# Android Indoor Station Firmware

## V2.1.28\_210803 Release Note

### (2021-08-05)

Device Model	DS-KH9310-WTE1, DS-KH9510-WTE1
Firmware Version	Android Indoor Station : V2.1.28_210803
iVMS-4200 Version	Latest baseline
Hik-Connect APP	Latest baseline

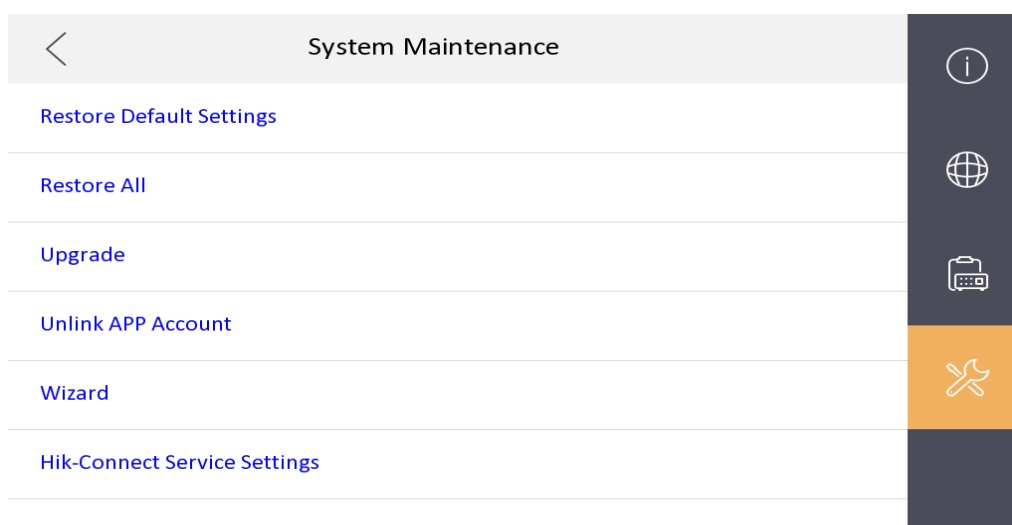
1. Verification code is empty by default.
